ADDENDUM

ADDENDUM NO.: 02
PROJECT NAME: Kenwood Academy Link and Mechanical (Rebid)
PROJECT NO.: 05326
CONTRACT NO.: C1602R
DATE OF ISSUE: February 29, 2024

NOTICE OF CHANGES, MODIFICATIONS, OR CLARIFICATIONS TO CONTRACT DOCUMENTS

PBC Project Name: Kenwood Academy Link
PBC Contract No: C1602R
Project No.: 05328
Title: ENLARGED VIEWS PLAN II

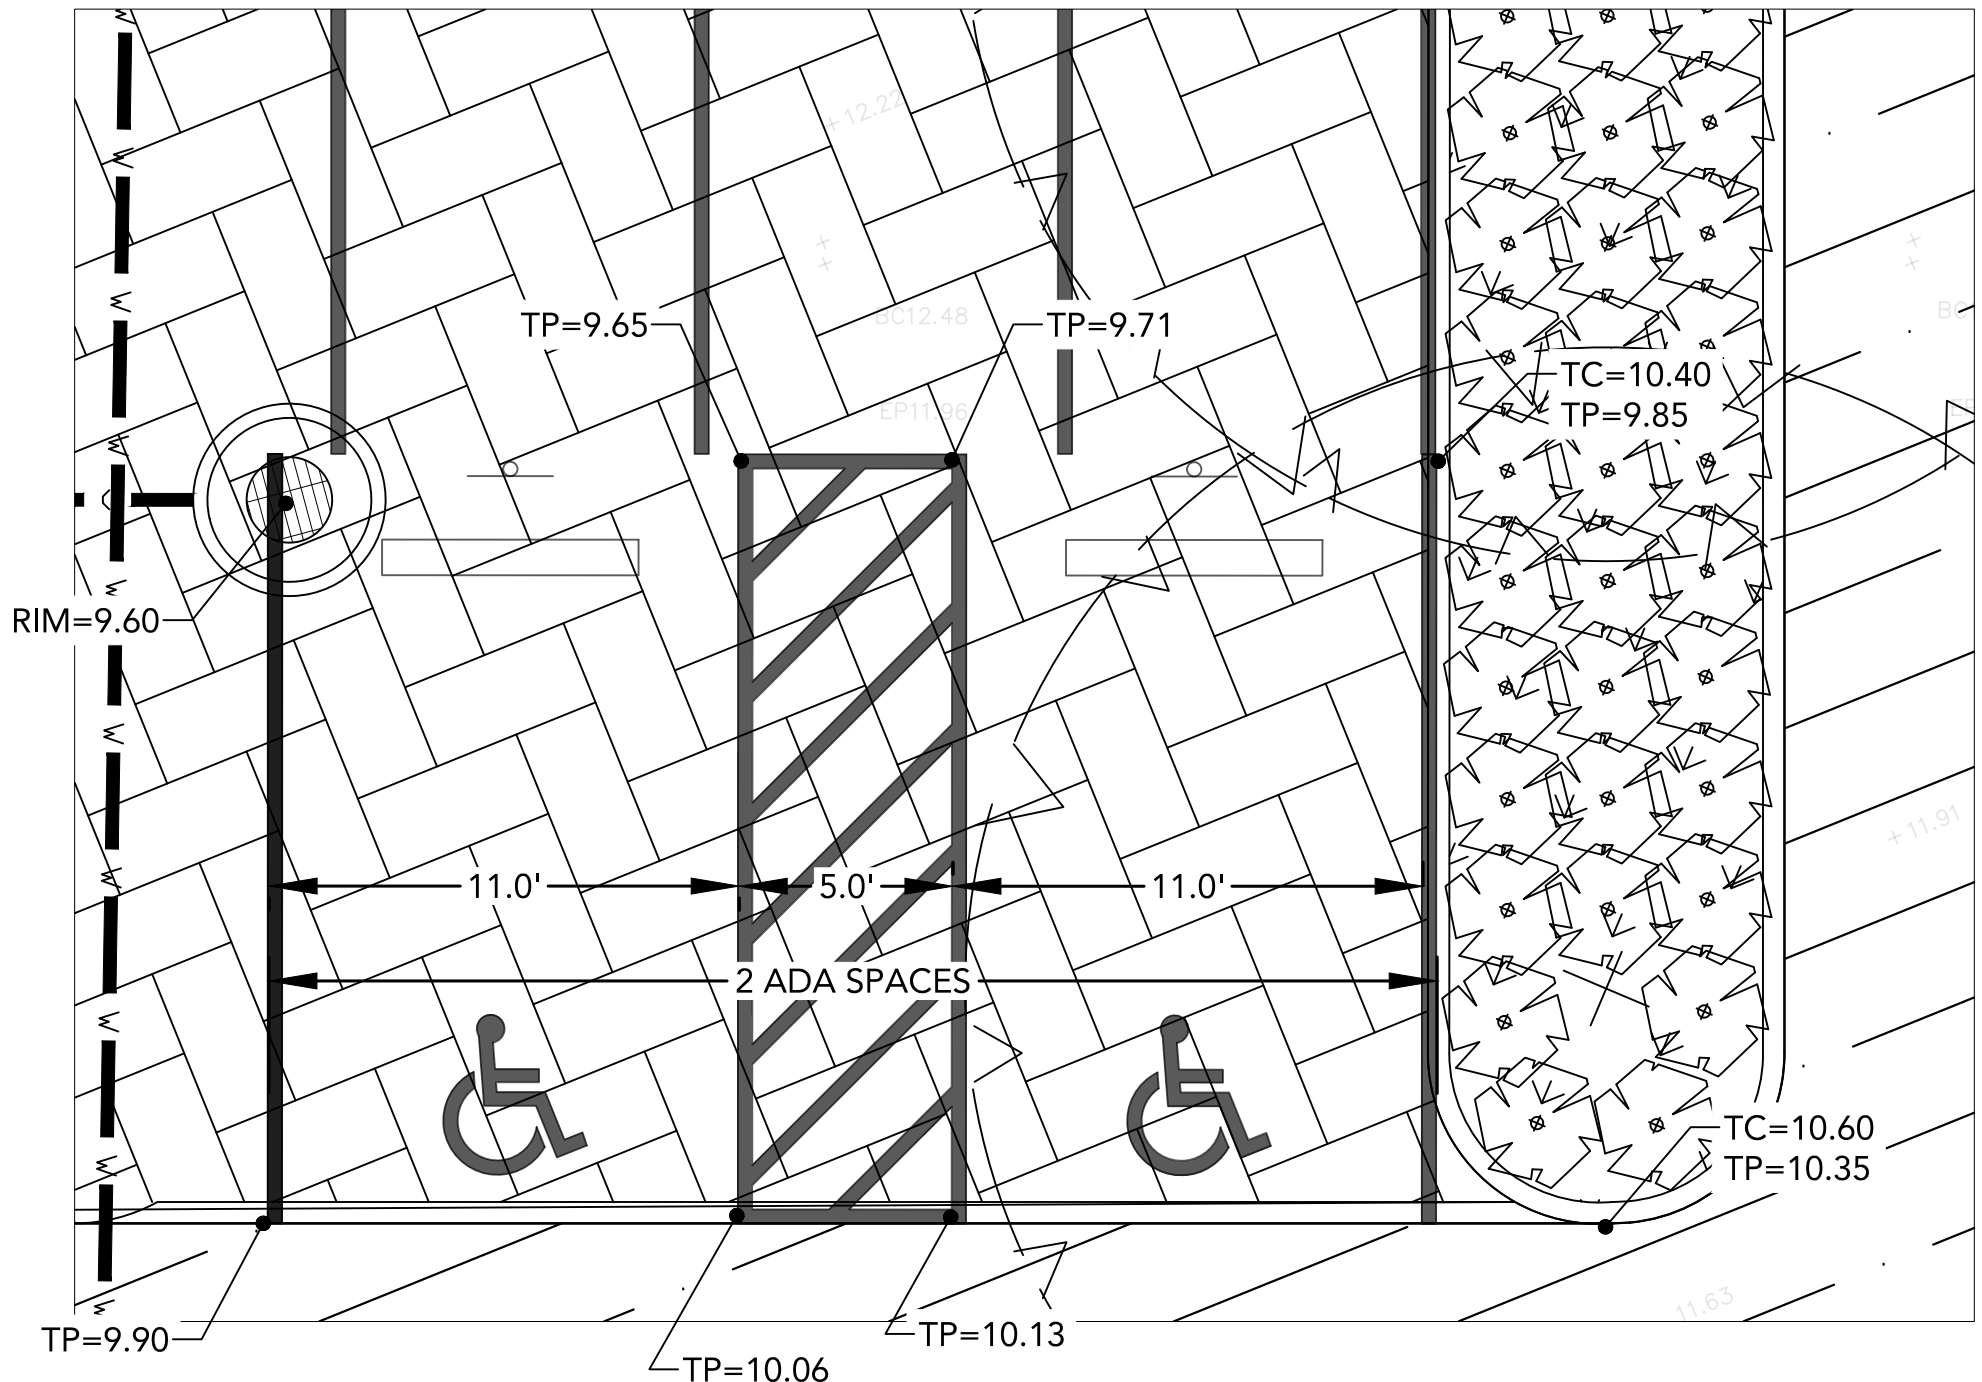
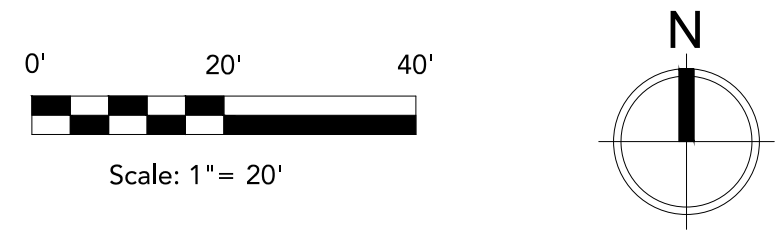
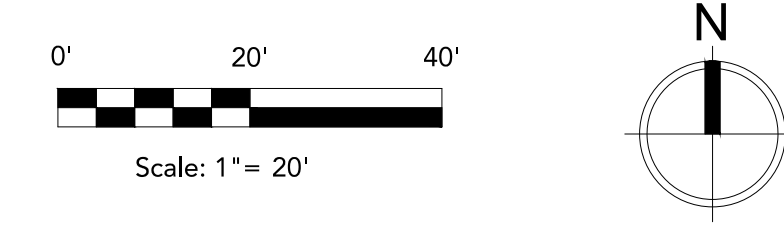
Change 4 C-108 - ENLARGED VIEWS PLAN II; **REVISED** to add notations enlarged driveway view (1/C-108)

Question: At the new entrance, the Teacher's Lot on E. Hyde Park Boulevard, where the driveway apron is proposed there are existing utilities that are not show on C-102 or C-108. During the site visit I observed an existing gas valve box, as well, as two manhole covers. One manhole lid on the sidewalk at proposed apron location, the other right behind the ornamental fence within the proposed drive. Please advise.

Response: The various utility manholes and valve boxes have been identified to be adjusted to the final grade of the driveway. Please refer to sheet C-102 and C-108 revised and included in this addendum.

Title
LANDSCAPE
SITE PLAN

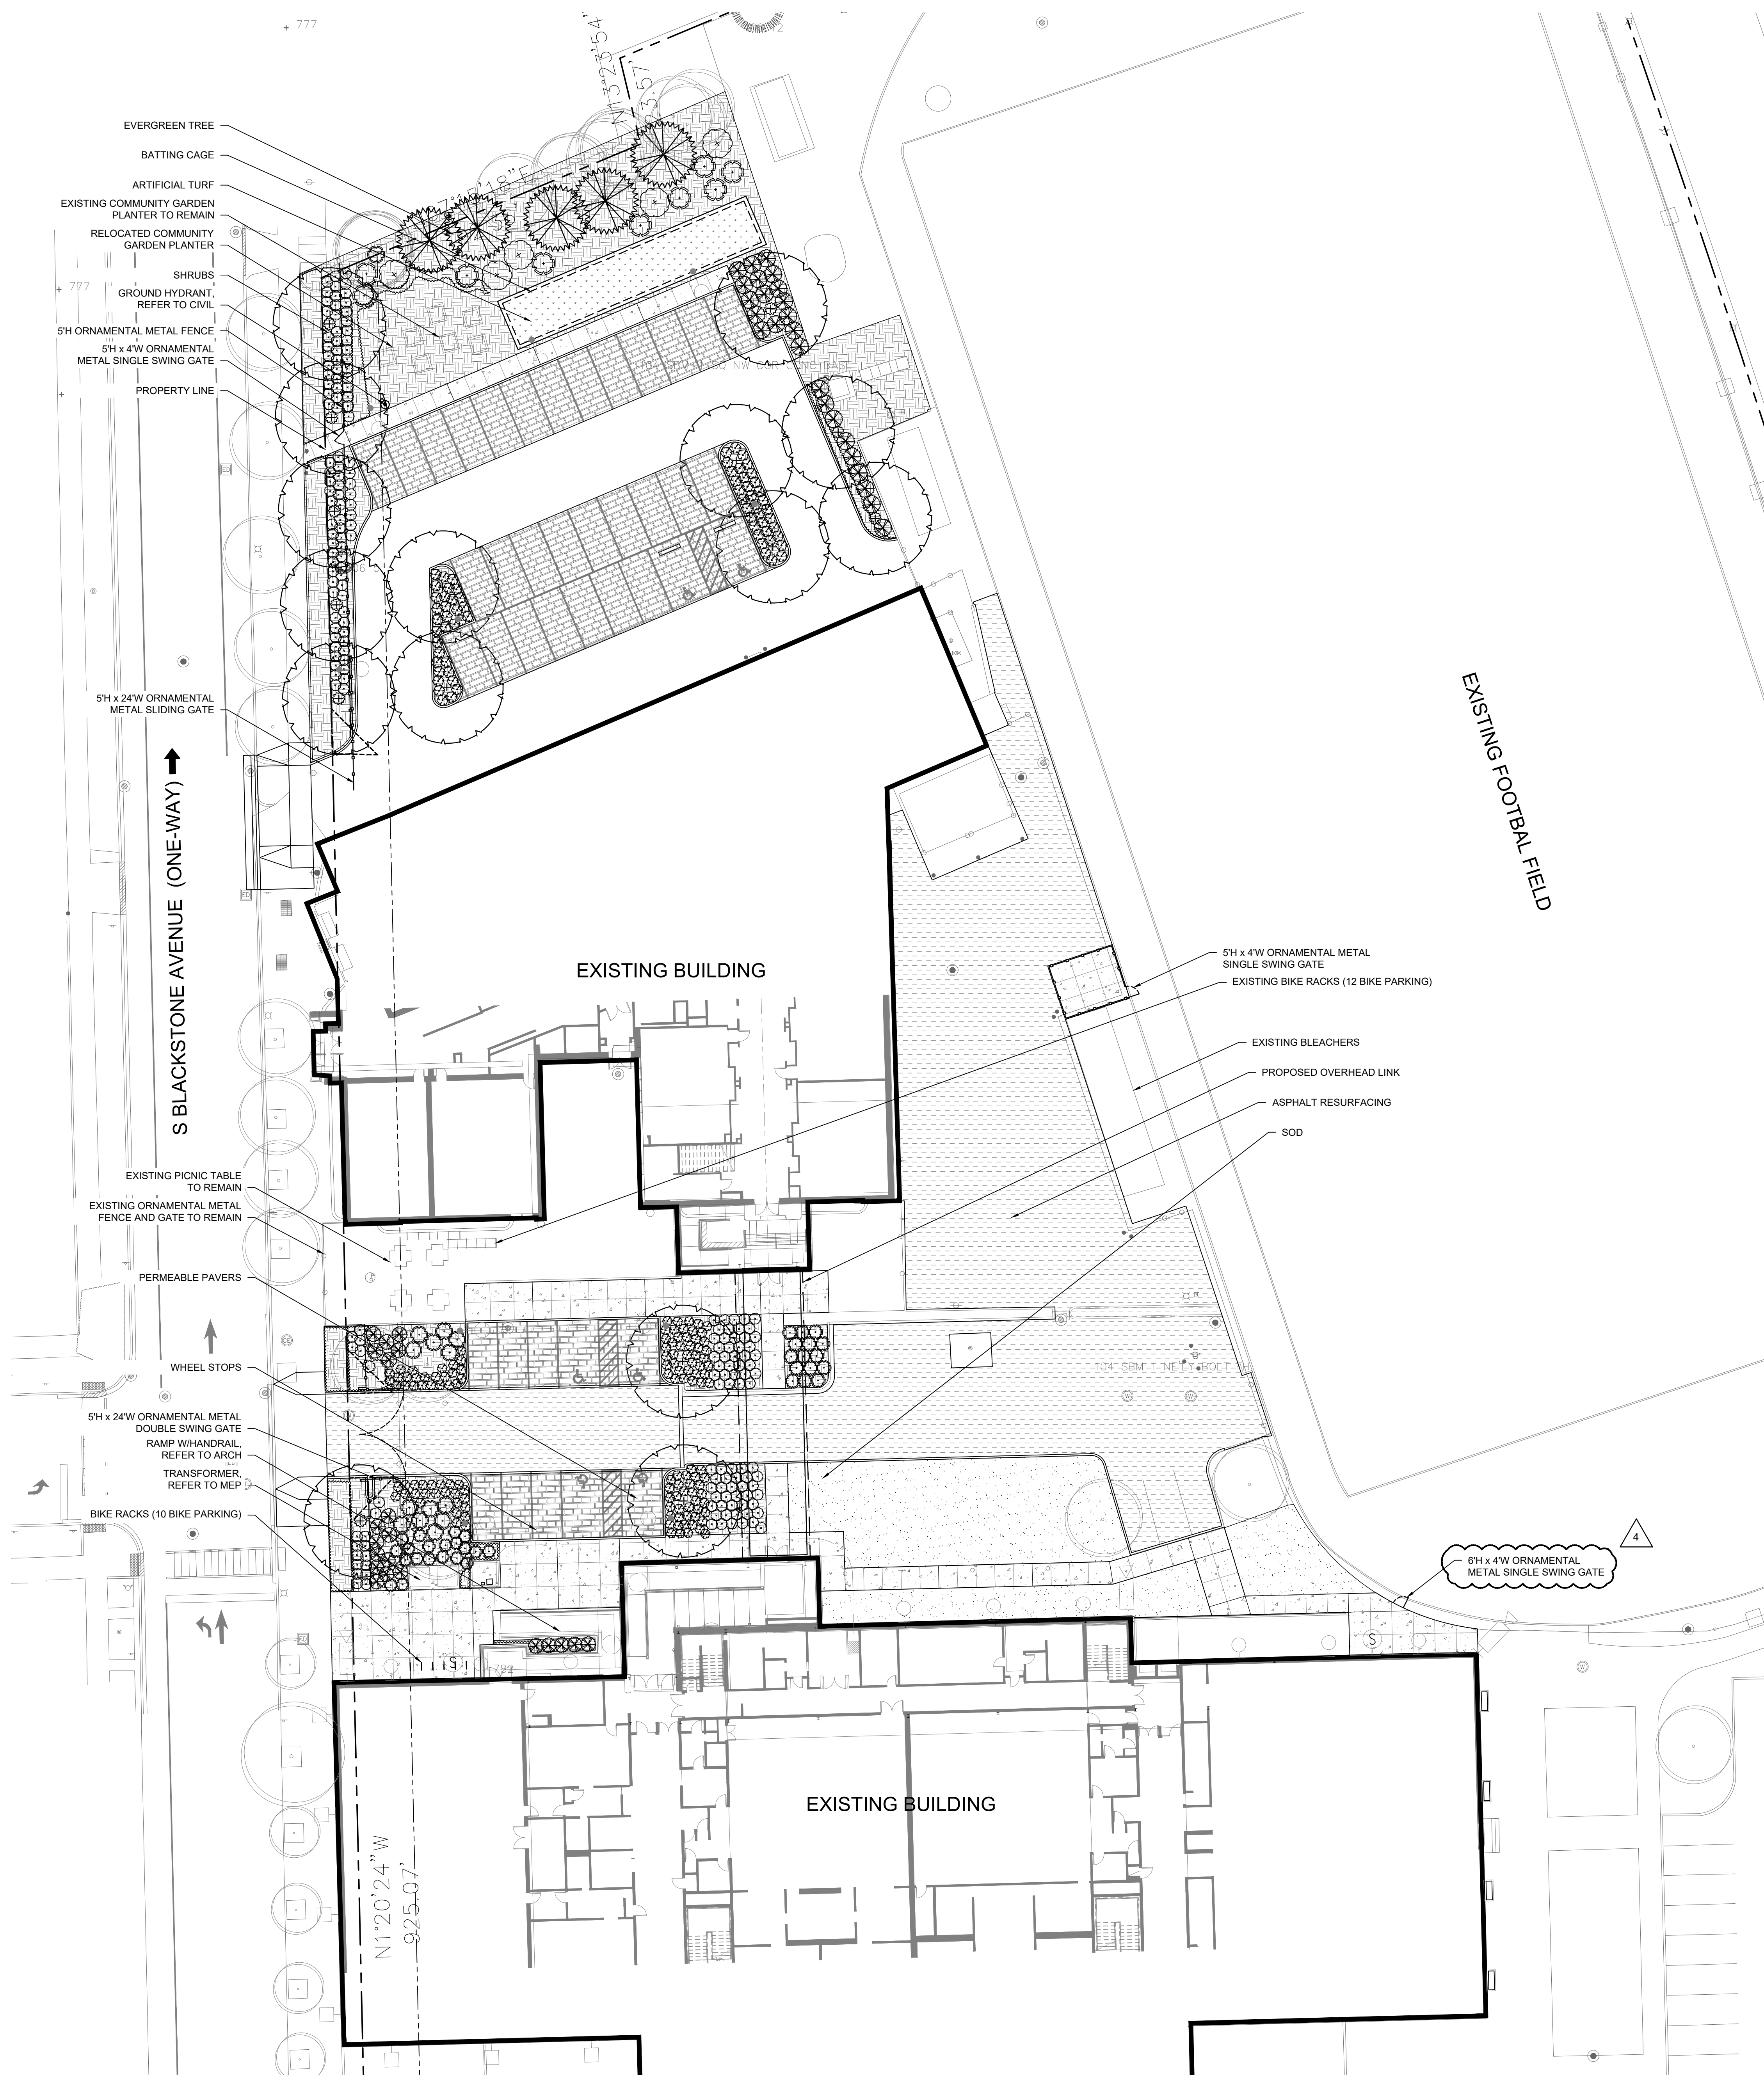
Change 5 L101 - LANDSCAPE SITE PLAN; **REVISED** to update notation regarding swing gate at the south west of the football field

PBC Project Name: Kenwood Academy Link -MEP
PBC Contract No: C1602R
Project No.: 05328
Title: SITE FENCING AND FURNISHING PLAN
Sheet: L104

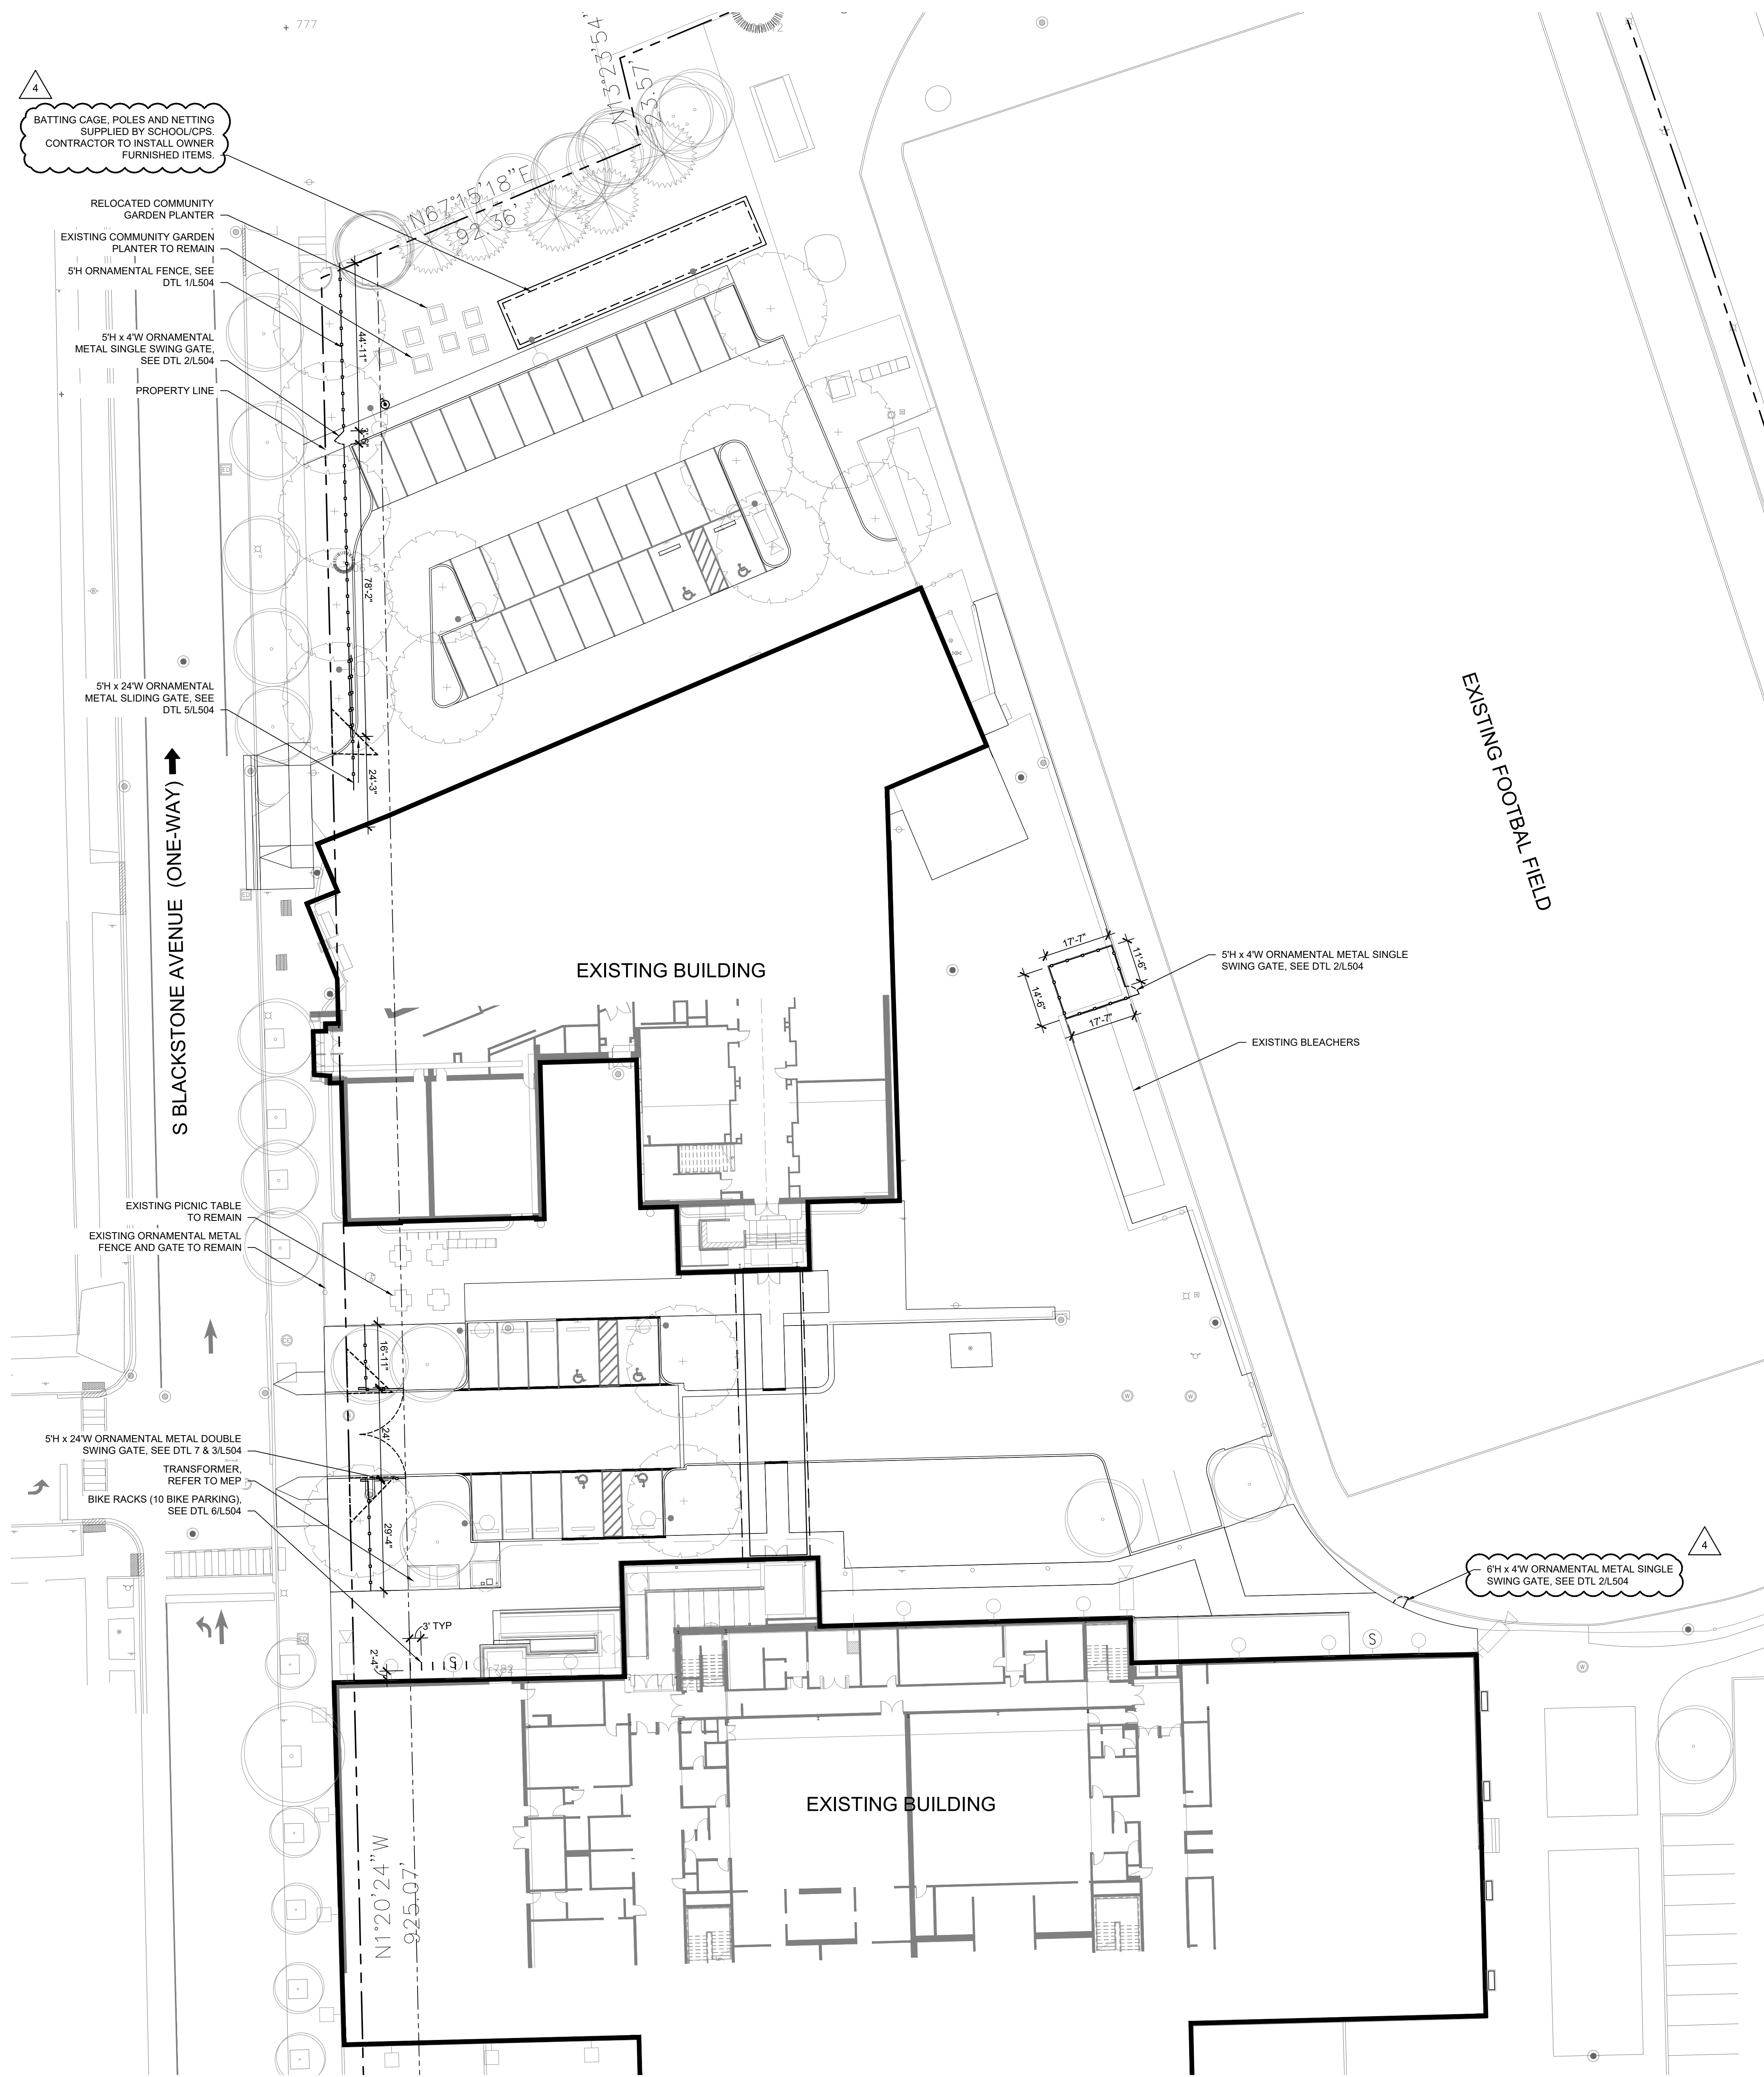
Change 6 L104 - SITE FENCING AND FURNISHING PLAN; **REVISED** to update notation regarding swing gate at the south west of the football field and notation regarding batting cage

RFI-1. There is a man gate shown to be installed on landscape and civil drawings at the southeast corner of the track/field fencing; however, it was confirmed that this gate should not be included in the scope. Please advise.

Question: Provide new ornamental gate scope as indicated on sheets L104 and L504 revised and included in this addendum.
